SERVICE BULLETIN

CHECKING OR REPLACEMENT OF FLEXIBLE FUEL LINE FOR ROTAX® ENGINE TYPE 912 (SERIES) SB-912-054

MANDATORY

Fig. 1

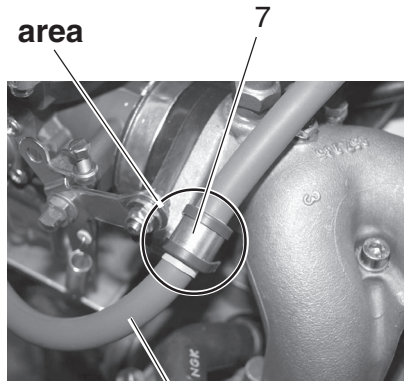
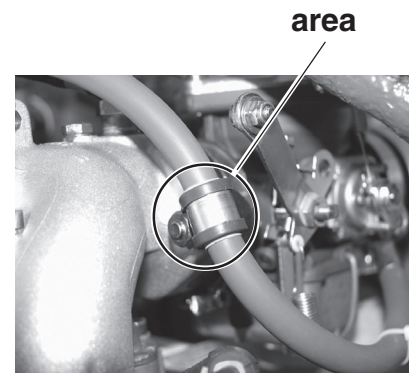
Visual inspection of the fuel line (1) in the area clamp (7) and both ends of the yellow protection cover. (see Fig. 1)

◆ **NOTE:** A possible crack can be observed by careful bending of the fuel line. If you notice cracks or porosity then you need to replace the fuel line in accordance section 3.1.2.

2. Install both cable clamp (7) in accordance with Fig.1 on the fuel line.

Fig. 2
08184

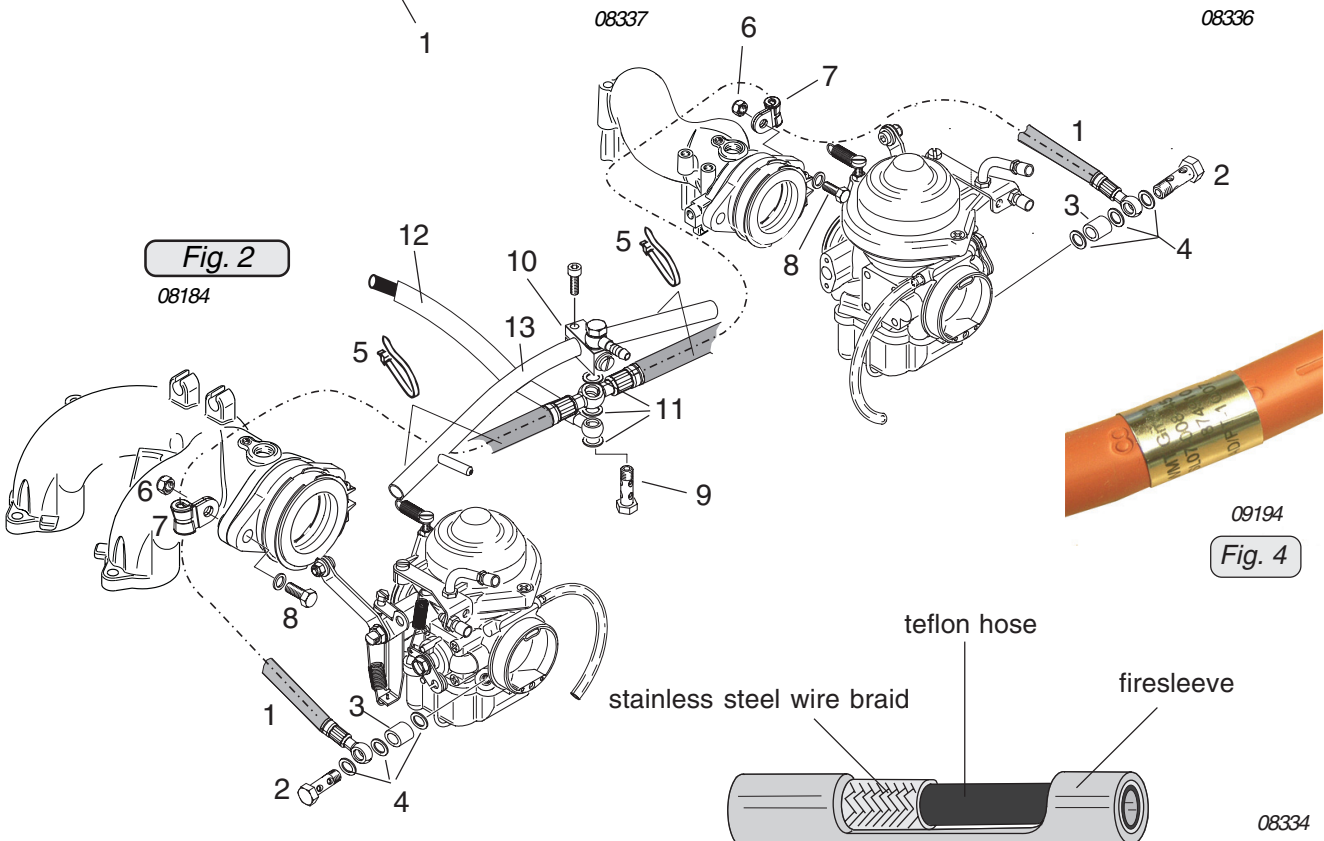
1. Unscrew the banjo bolt (2) with distance sleeve (3) and 3 gasket rings (4).

2. Cut the cable tie (5).

3. Remove hex. nuts M8 (6) together with clamp (7). Held in place by hex. screw (8).

4. Remove banjo bolt (9) from clamp block (10) together with 3 gasket rings (11).

◆ **NOTE:** The gasket rings 8x13 (4), used on the banjo bolt of the carburetor, are of different thickness compared to the gasket rings (11), used on the banjo bolt of the clamp block.

5. Remove the fuel line (12).

1. Install flexible fuel line (1 and 12) and the banjo bolt (9) with new sealing ring (11) on the clamp block (10). Tightening torque of banjo bolt (9) 10 Nm (90 in.lb). Check that the fuel lines are not under strain or tension.

3. Install the fuel line (1) with distance sleeve (3) and sealing ring (4) on the carburetors. Tightening torque of banjo bolt (2) 10 Nm (90 in.lb). Place cable clamp (7) into position.

4. For proper support. Install the clamp (7) and hex. nut M8 (6) with LOCTITE 221. Tightening torque of hex. nut (6) 15 Nm (133 in.lb).

5. Fix the fuel line at the compensation tube with 2 cable ties (5).
